Access Compliance Report

Public Rights-of-Way

(Curb Ramps)

Intersection ID: 10037245	Main Street: SARDIS_CROSSING_DR	Cross Street: N/A	Location: SW
ADA ID: 577B3ACC3A8B	Ramp Type: Perp	Initial Pass/Fail: Fail	Overall Compliance: No
		Severity Score: 22.5

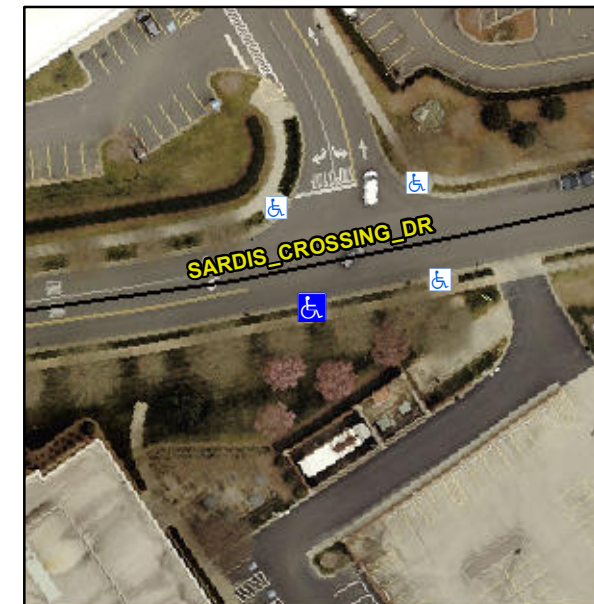
Not Found, R304.5.1, R304.2.2

Compliance	Description	Data	Compliance	Description	Data
N/A	Ramp Length (in)	47.0	No	Ramp Slope (%)	9.4
No	Ramp Width (in)	47.0	Yes	Ramp XSlope (%)	2.9
N/A	Flare Type LT	N/A	N/A	Flare Type RT	N/A
N/A	Flare Slope LT (%)	N/A	N/A	Flare Slope RT (%)	N/A
N/A	Flare Traversable LT?	N/A	N/A	Flare Traversable RT?	N/A
N/A	Landing Length (in)	N/A	N/A	DWS Provided?	N/A
N/A	Landing Width (in)	N/A	N/A	DWS Contrast?	N/A
N/A	Landing Slope (%)	N/A	N/A	DWS Length (in)	N/A
N/A	Landing X Slope (%)	N/A	N/A	DWS Full Width?	N/A
N/A	Landing Curb? (Y/N)	N/A	N/A	DWS Offset (in)	N/A
N/A	Shared Landing?	N/A			
N/A	Gutter Ponding?	N/A	N/A	Gutter Slope (%)	N/A
N/A	Gutter Lip Ht (in)	N/A	N/A	Gutter X Slope (%)	N/A
N/A	Painted X Walk1?	No	N/A	Painted X Walk2?	N/A
	X Walk 1 Direction	To N		X Walk 2 Direction	N/A
N/A	X Walk 1 Width (in)	N/A	N/A	X Walk 2 Width (in)	N/A
	X Walk 1 Slope (%)	2.1		X Walk 2 Slope (%)	N/A
	X Walk 1 X Slope (%)	3.4		X Walk 2 X Slope (%)	N/A

Remove & Replace Entire Ramp.
